**FORT LESLEY J. McNAIR
PHYSICAL FITNESS CENTER**

Delegated Action of the Executive Director

March 30, 2006

REVISED CONCEPT SITE PLAN

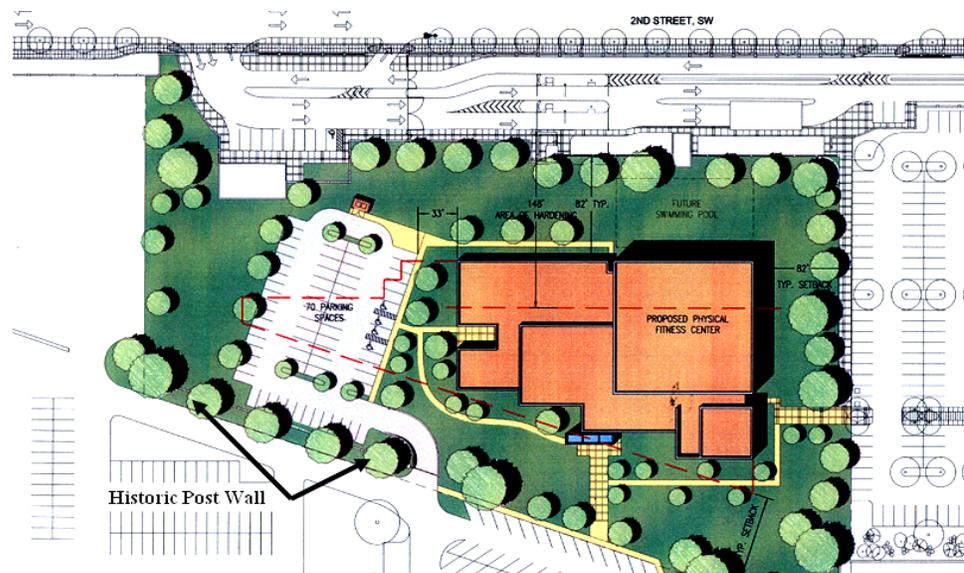
- It maintains and strengthens the building line established by Lincoln and Marshall Halls.
- It provides for future space to accommodate an exterior pool, thereby allowing for the removal of the existing swimming pool that the Commission has previously recommended be removed.

- The façade materials and relate well to the existing vocabulary at Fort McNair of primarily brick. The entrance façade creates a well-defined and subtle but doorway, which features an open overhead trellis.
- Recessed brick patterning of the gymnasium exterior walls provides interest and scale break-up of the reinforced and hardened east building perimeter. The historic post wall is incorporated into the site design at the northwest site boundary.
